Project	IEEE 802.16 Broadband Wireless Access Working Group < http://ieee802.org/16 >	
Title	Consideration on BS-BS Communication over the Air for Dynamic Resource Sharing	
Date Submitted	2006-02-28	
Source(s)	David Grandblaise Motorola Labs Parc Les Algorithmes Commune de Saint Aubin 91193 Gif sur Yvette, France	Voice: +33 (0)1 6935 2582 Fax: +33 (0)1 6935 4801 mailto: david.grandblaise@motorola.com
Re:	Call for Contributions, IEEE 802.16h Task Group on License-Exempt Coexistence, IEEE 802.16h-06/004	
Abstract	The credit tokens based co-existence and negotiation protocol can be enabled by with IP-based wired communications (using the shared distributed system architecture) and over the air signaling. This contribution proposes basis for over the air signaling between BSs for OFDMA PHY.	
Purpose	This contribution proposes basis for OFDMA frame structure in support of BS-BS communication over the air for dynamic resource sharing.

Consideration on BS-BS Communication over the Air for Dynamic Resources Sharing

Text proposal for section 15.7.2.2.6.4

Figure 1: DL and UL BS-BS sub-channels

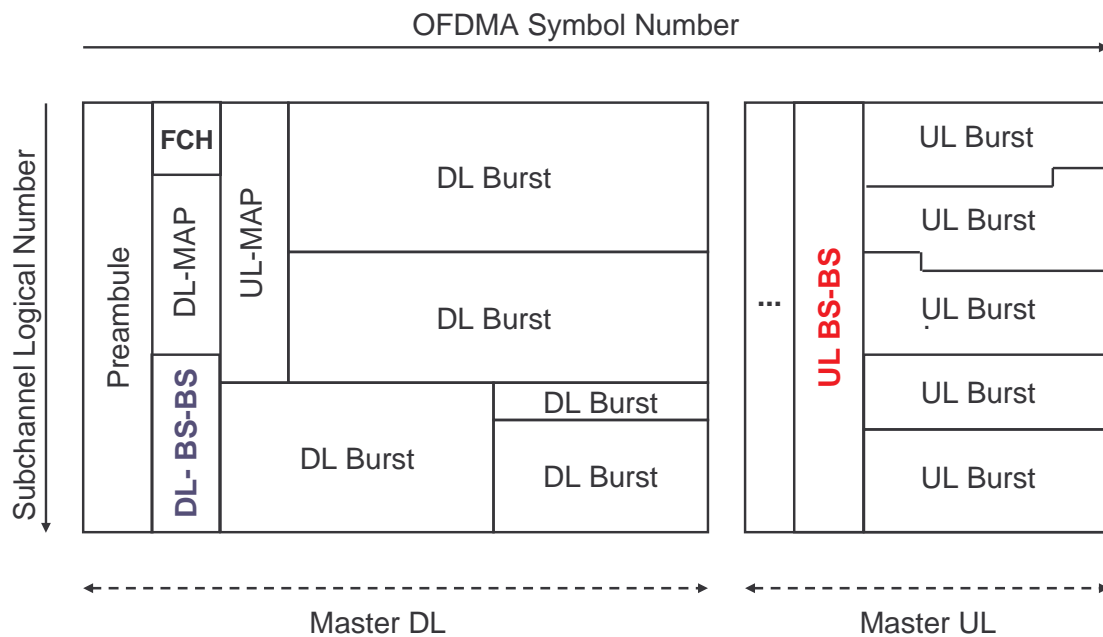
To support both DL BS-BS and UL BS-BS signaling, it is proposed to introduce a DL BS-BS sub-channel and a UL BS-BS sub-channel. These sub-channels are depicted in figure 1 for TDD OFDMA PHY. Both DL BS-BS and UL BS-SB sub channels are active only when the master BS decides to open temporally for renting some channels.

The UL BS-BS transmission acts as a SS's transmission. The master BS allocates (in UL-MAP) the uplink resources between those dedicated to the SSs (UL Bursts) and those for the UL BS-BS channel in uplink. The UL-MAP provides the necessary IEs about the UL BS-BS sub-channel availability and usage for the slave BSs during the different sequences of the cycle.

The DL BS-BS sub-channel usage is provided in DL-MAP.
